HNHS -Ceiling, Lights, PA, Piping Systems Replacement

Project # 2024.0003

September 19, 2024

ADDENDUM NO. A-2

SHEET
MDI.1D

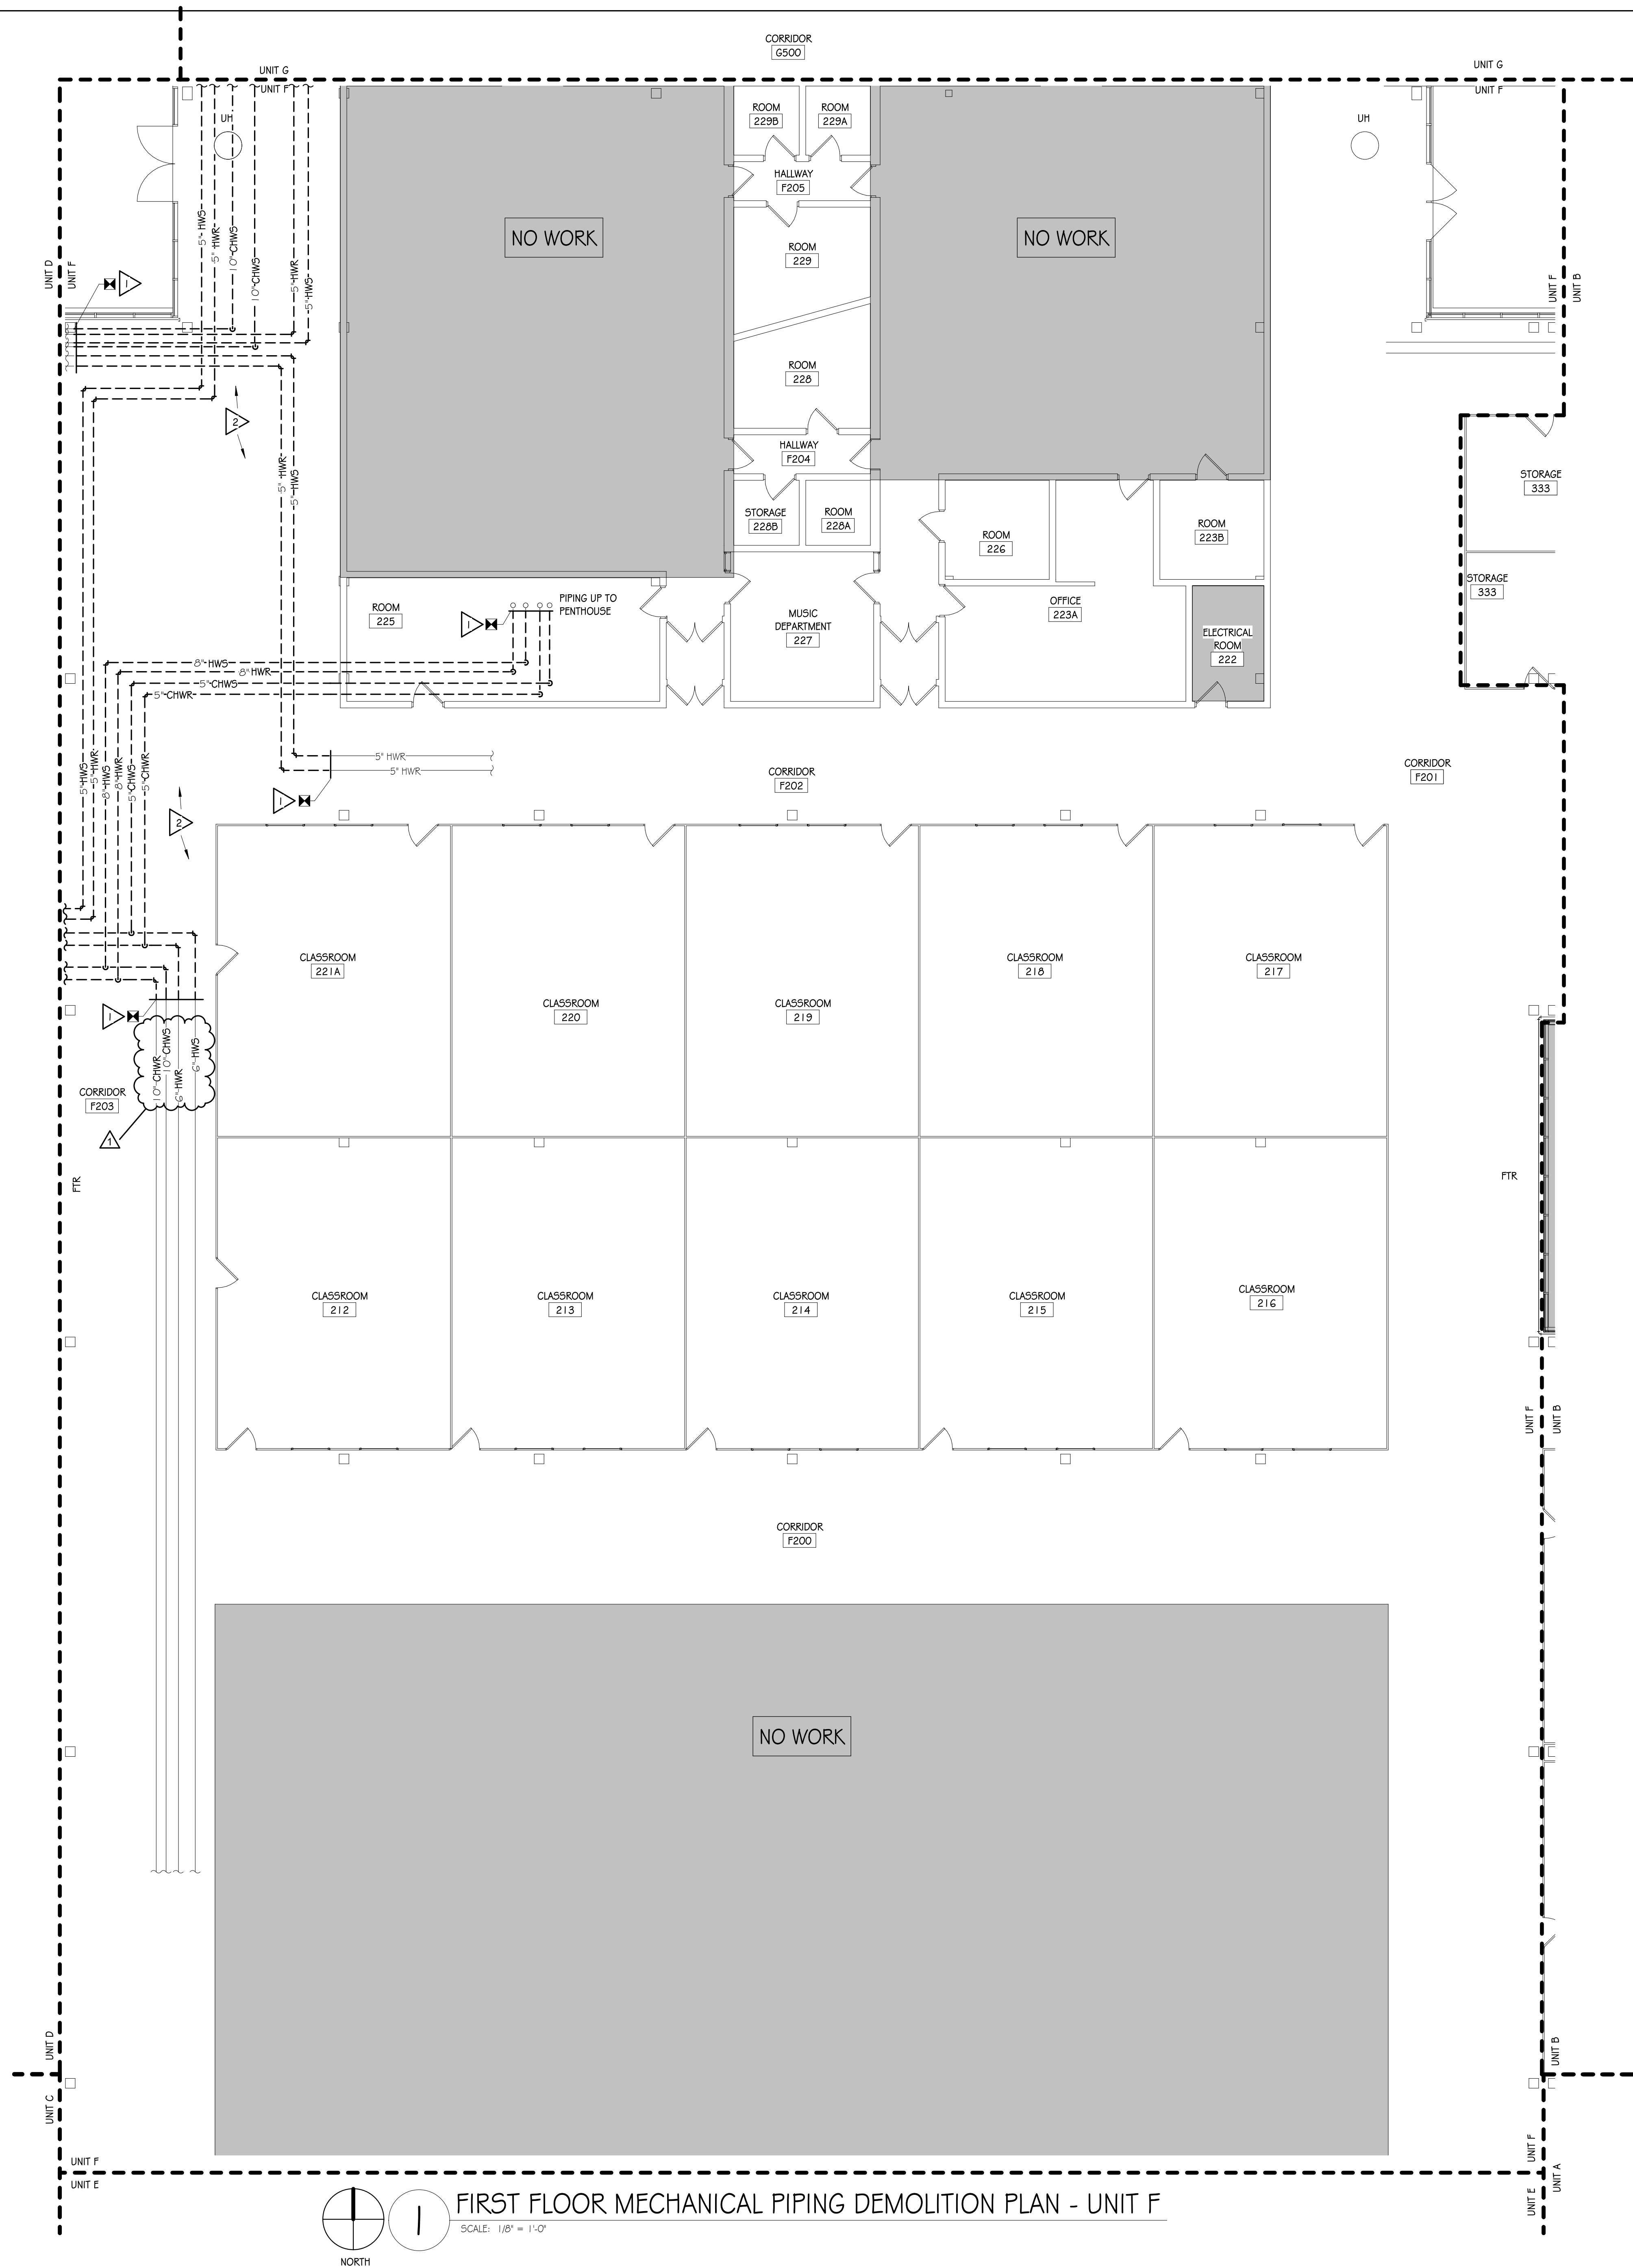
- Item:** A-2.7
Location: Drawings Sheet MD1.1D, MD1.1F
Description: Delete Sheets MD1.1D and MD1.1F in their entirety and replace them with the attached Exhibit A-2.3, Sheet MD1.1D and MD1.1F.
